Applies To: **2009–11 Civic** – ALL VINs Beginning With 2HG

**December 22, 2020**

## Gap Between the A-Pillar Trim and the Headliner

(Supersedes 11-064, dated February 3, 2012, to revise the information marked by the black bars)

**LEFT SIDE**

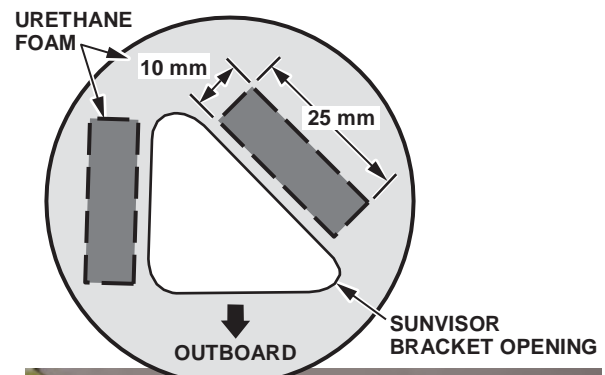
14. On the top of the headliner, attach two pieces of urethane foam near each sunvisor bracket opening as shown.

Urethane Foam: P/N 84101-SNA-999  
 (No longer available. Use commercially available urethane foam with a minimum height of **5 mm**.)
